21-COA-0089
1473 St. James Ct.

Old Louisville Architectural Review Committee
Public Hearing

Bradley Fister, Historic Preservation Specialist
May 12, 2021

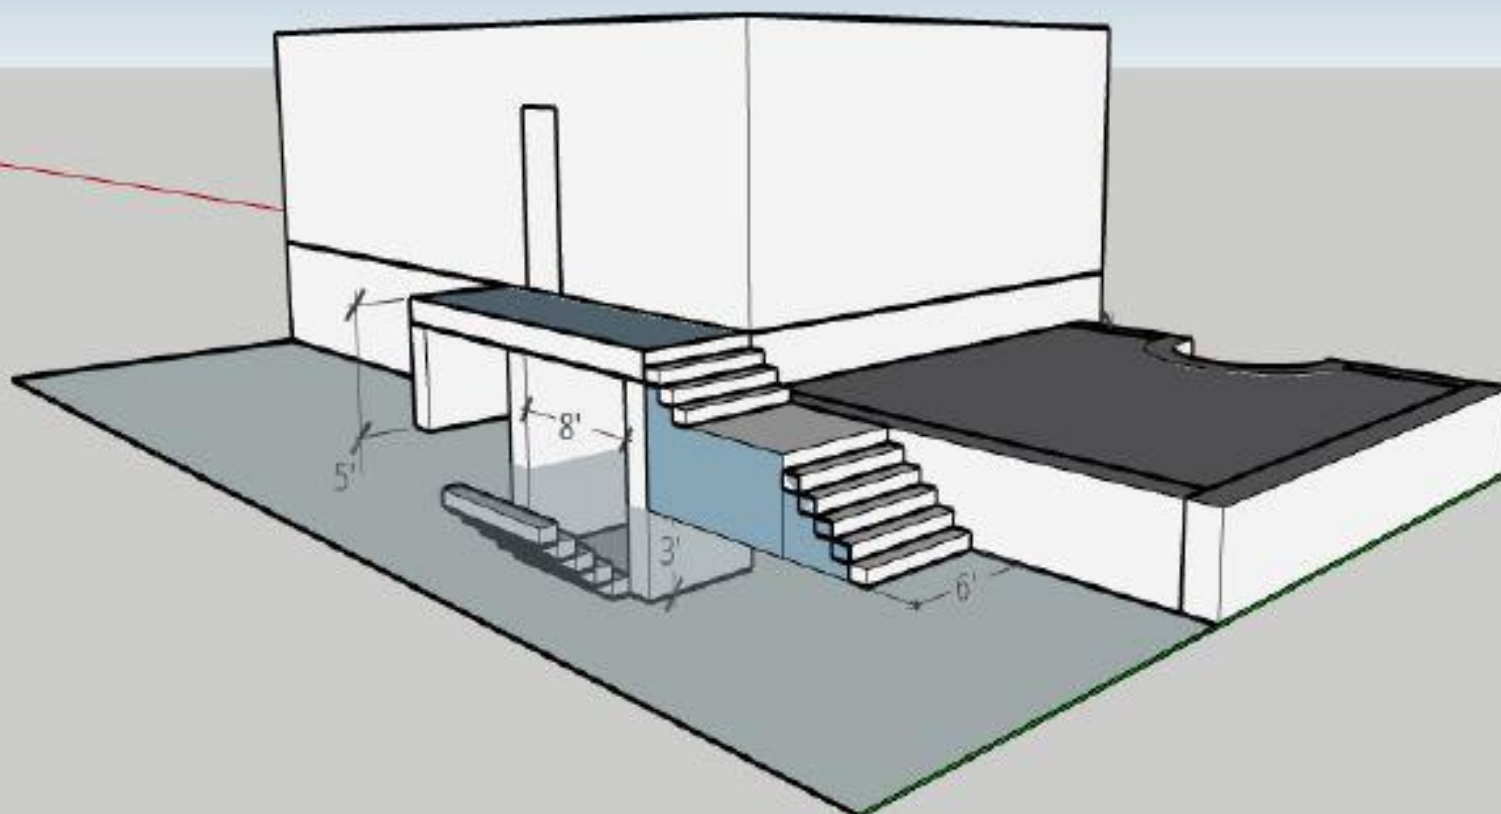
In terms of the **Site Guidelines**, the project generally meets the Old Louisville Design Guidelines with the exception of **ST10**, which states that new masonry structures shall not be visible from the street unless they are used for the retention of soil. The proposed work is complementary to the existing structure per **ST1**, and follows the existing property lines per **ST2**. In regard to **ST14**, which calls for historic precedent for fencing in the front of the home, there is currently an existing wood privacy fence, the material of the fence is what is being proposed to change. This existing fence is located adjacent to the house and not at the sidewalk, as well.

In regard to the proposal of the walls and fountain, though they generally do not meet the Old Louisville Design Guidelines for **Masonry**, they are in keeping with the style and character of the existing building. There is an existing masonry wall on the Saint James Ct. elevation. The proposed masonry structures are not falsely historic and shall be compatible with the building and district in size, scale, material and color.

4. The painting of the proposed new masonry construction shall not be the same color as the homes foundation in order to distinguish between what is historic and what is not, and the color shall be presented to staff prior to painting for approval.
5. The existing historic brick wall shall not be painted.
6. The proposed brick wall with patio above shall not exceed 7' in height at top of gallery rail.

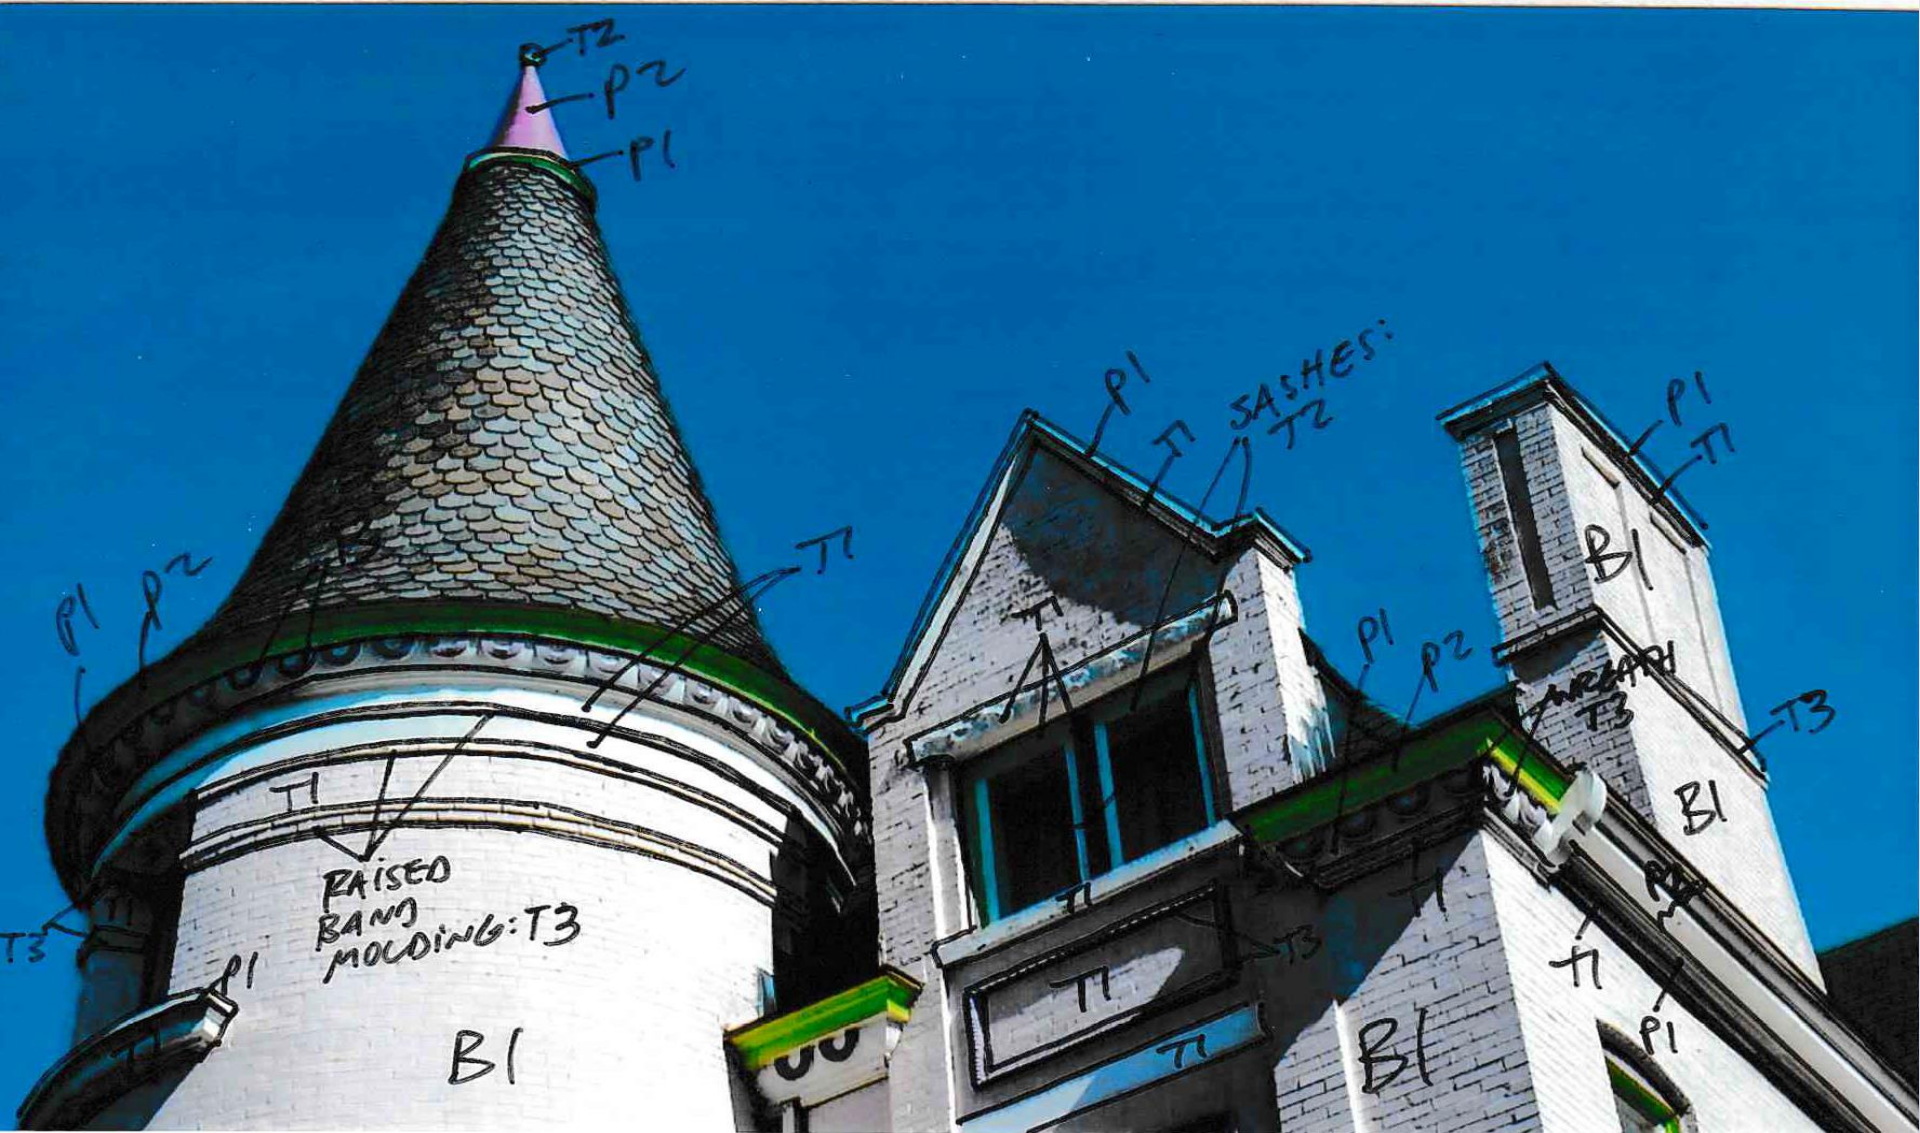
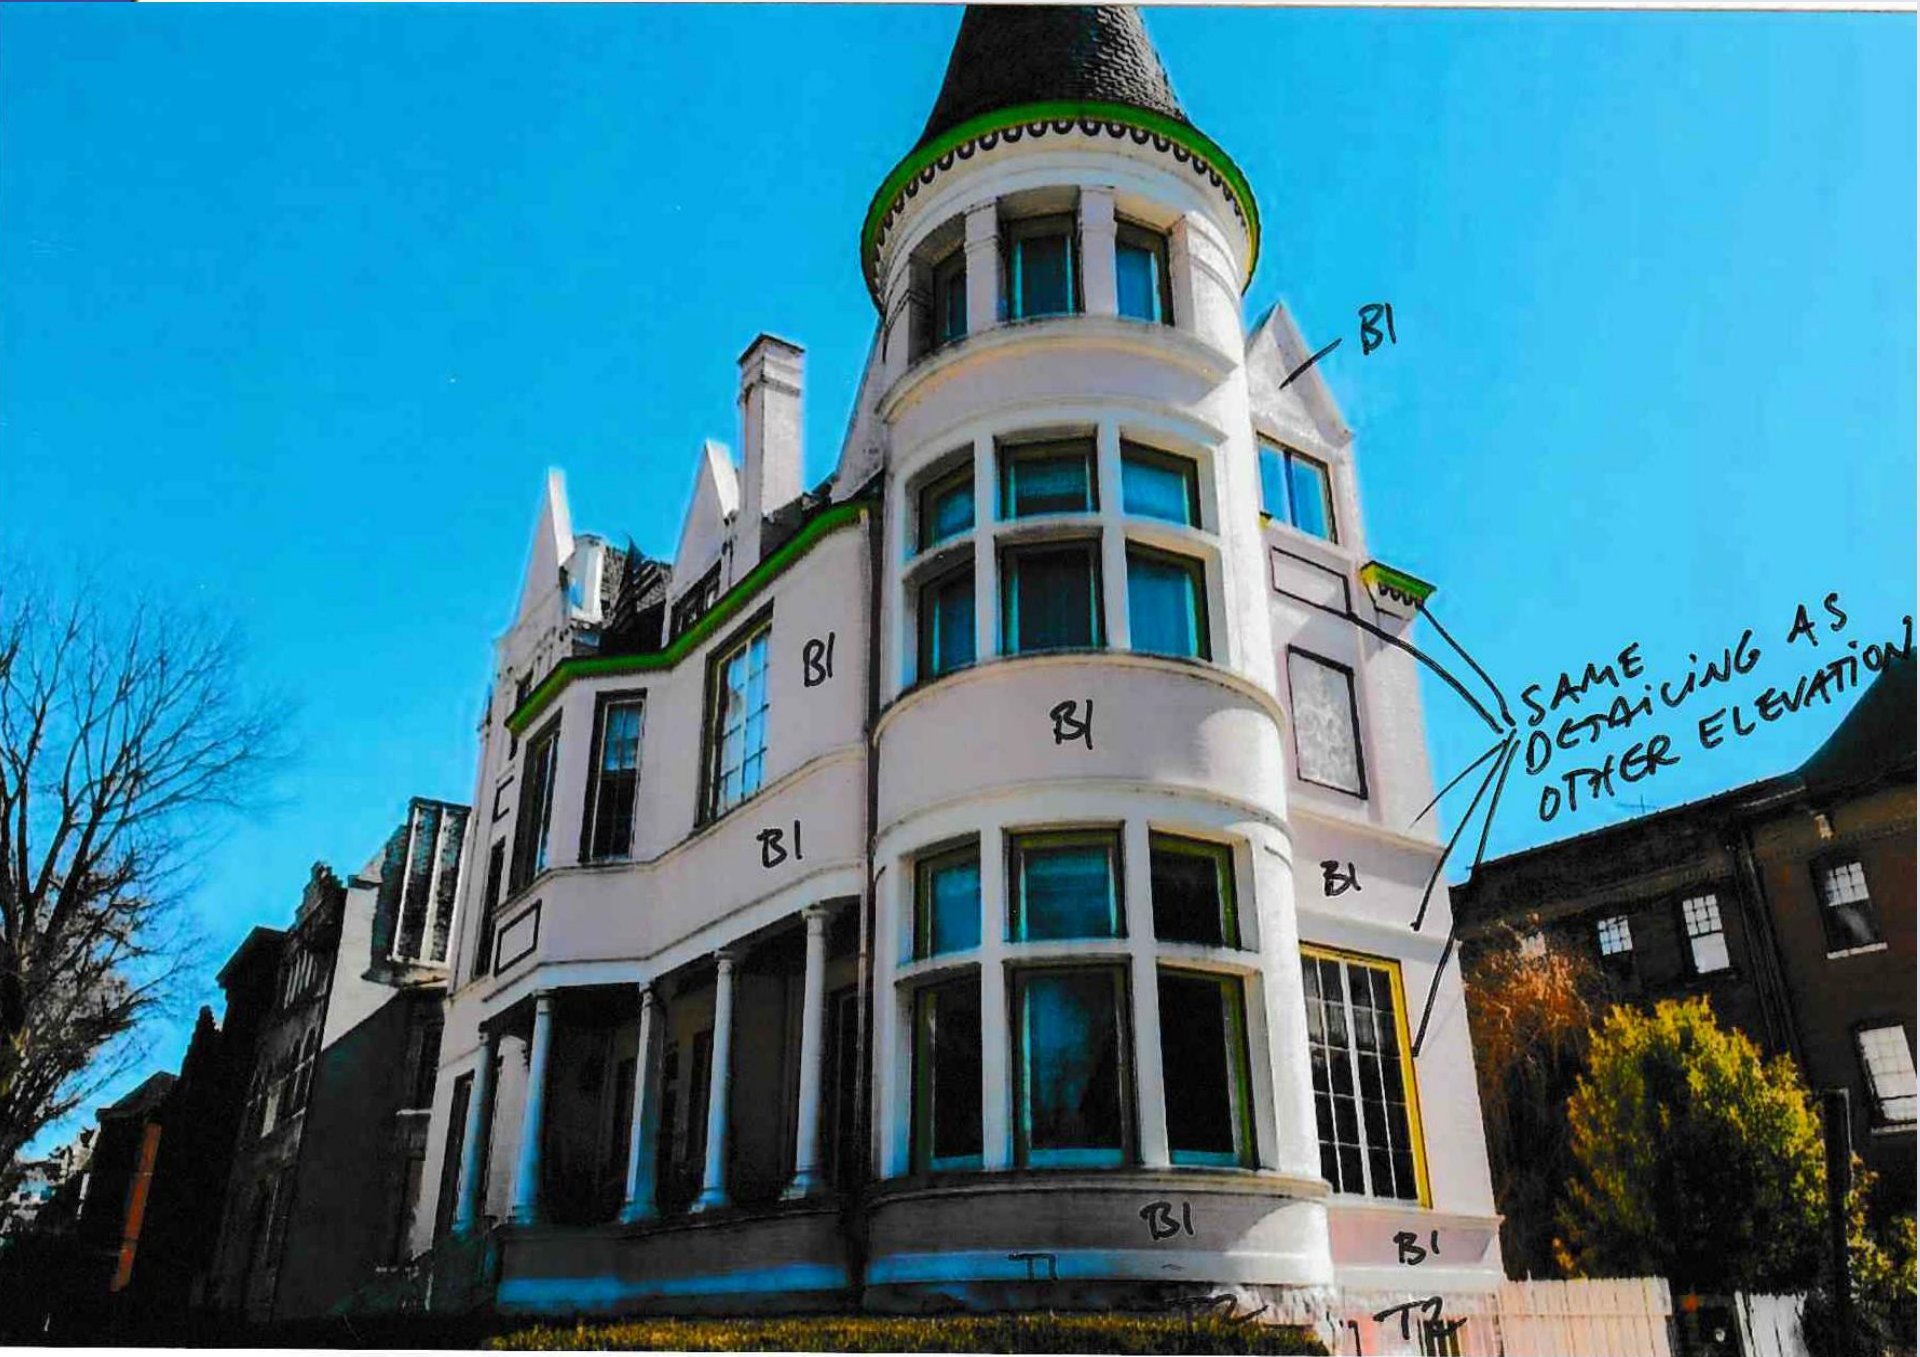
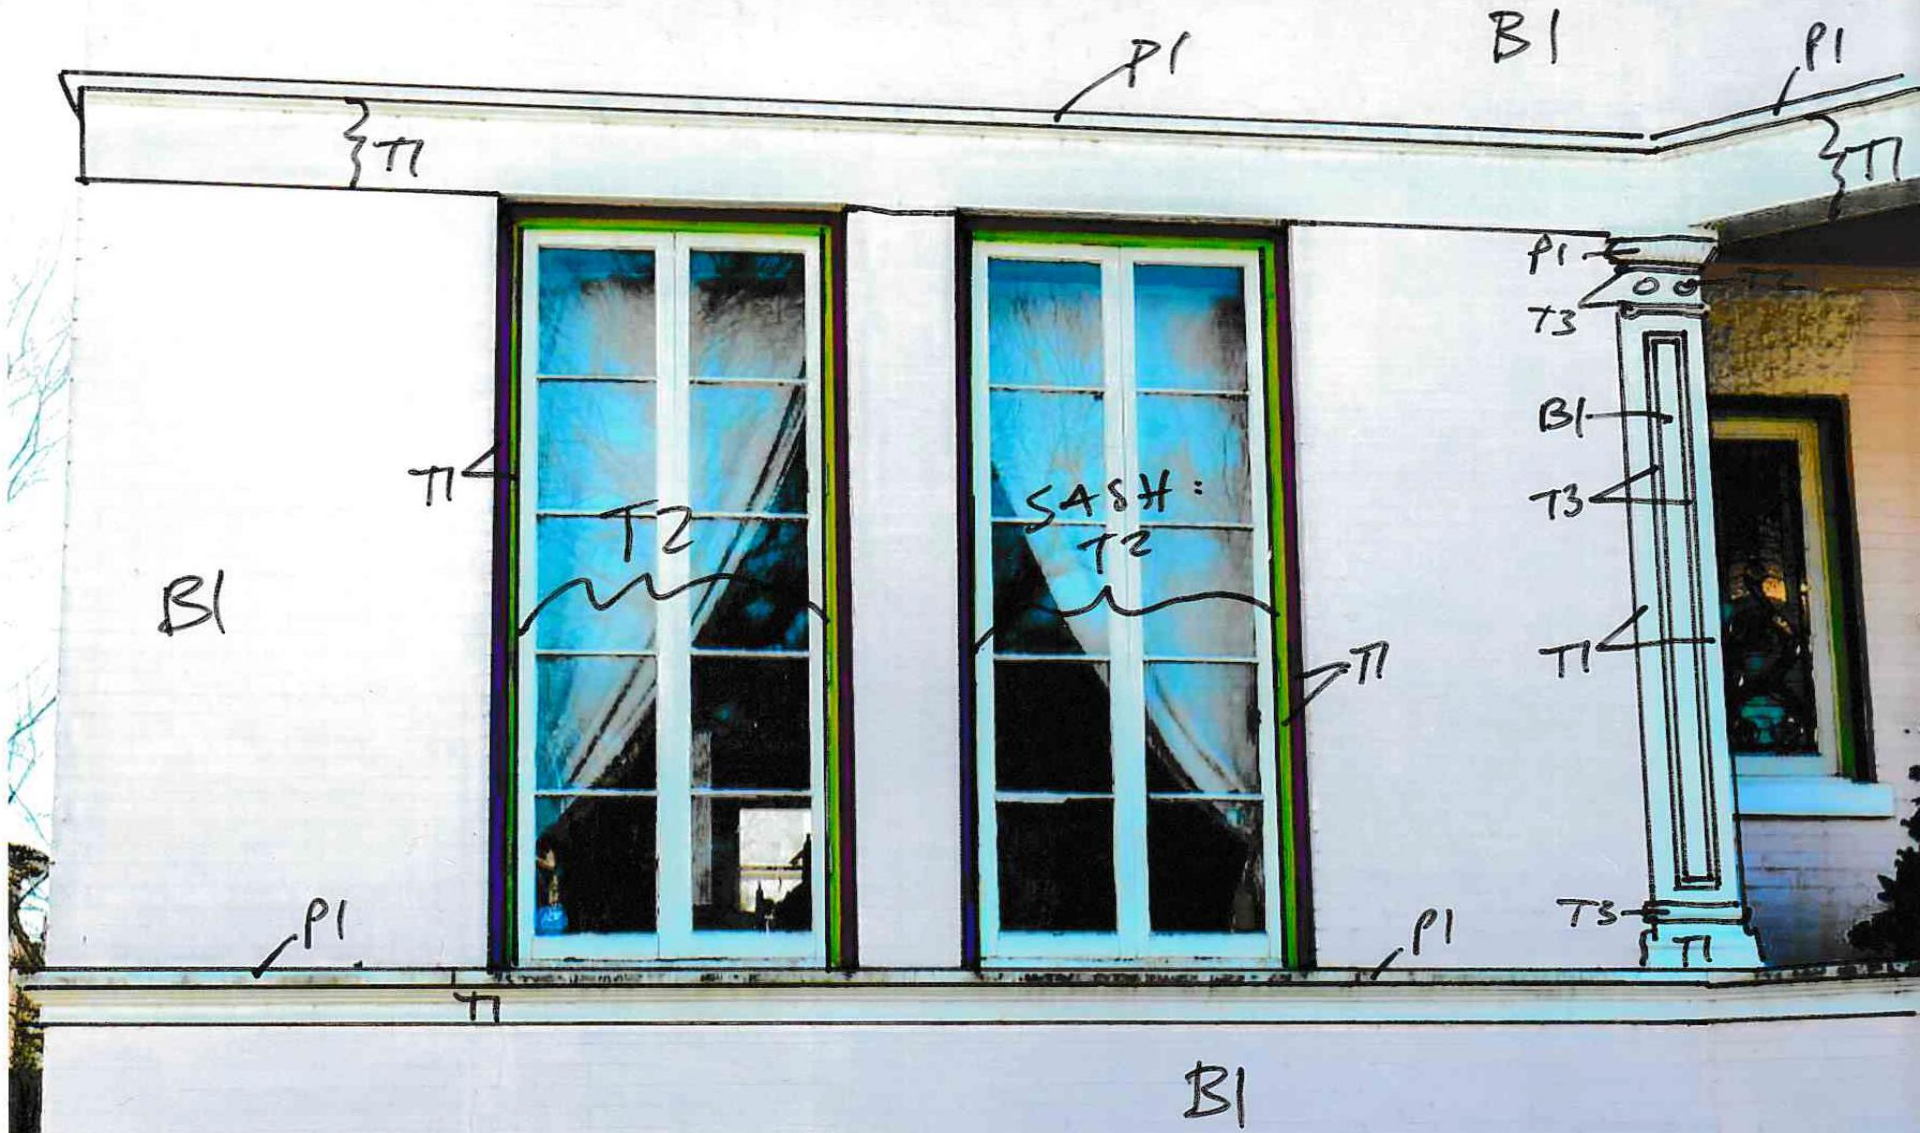
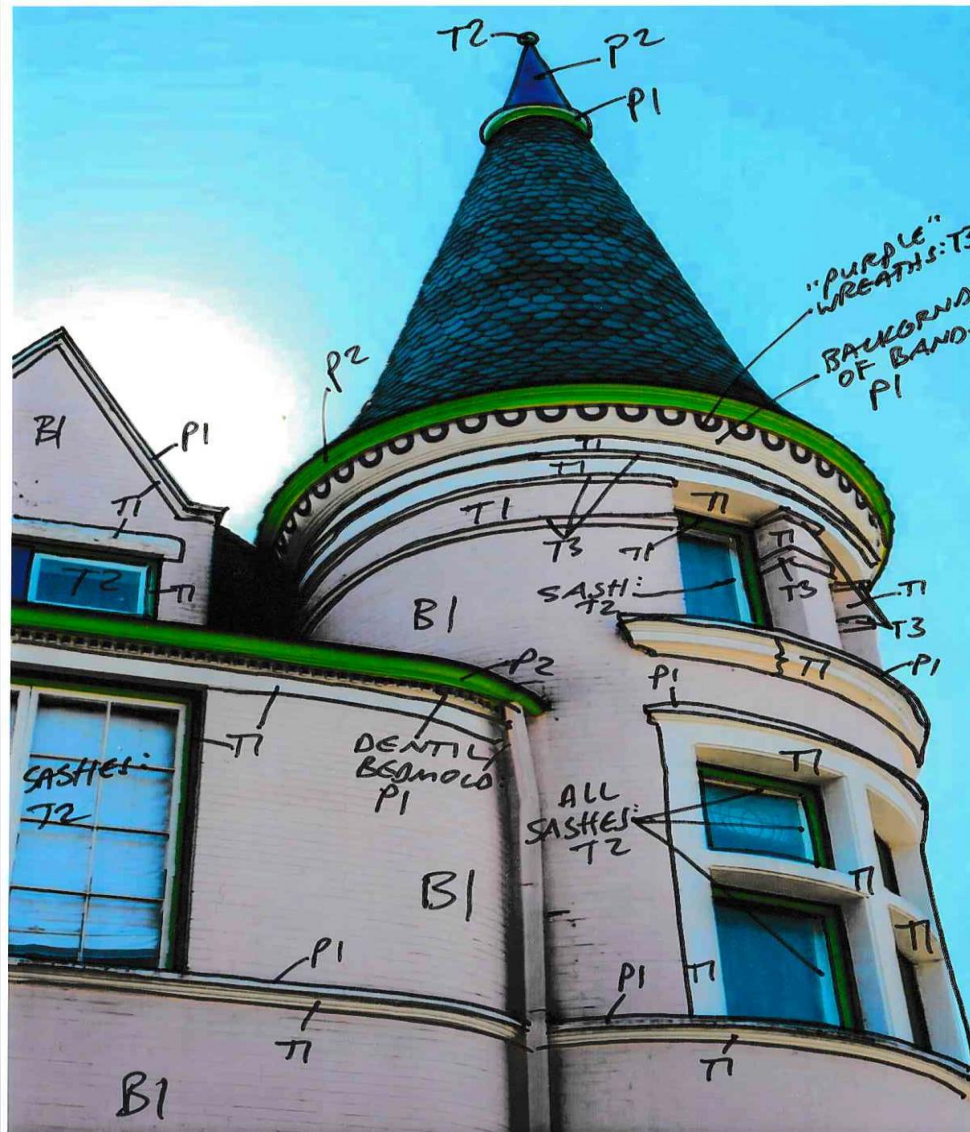
In regard to the **Paint Guidelines**, the proposed painting of previously painted masonry, the primary surface is proposed to be in the same color family as the existing as stated in **P4**. The applicant has had the paint professionally analyzed per **P5** and the proposed colors are what is suggested as a color closer to the original color of the home. The proposal to paint the proposed new brick elements the color of the homes foundation generally meets **P1** since the brick will not be historic in nature the paint will adhere better. The proposal to paint the existing historic brick wall generally does not meet **P1**, as it is an unpainted masonry surface.

1. The painting of the existing brick shall be done according to the color chart provided, any deviation shall be approved by the committee prior to painting.
2. The applicant shall take proper safety precautions in working with the existing paint due to possible exposure to toxins.
3. The applicant shall apply a breathable masonry paint.
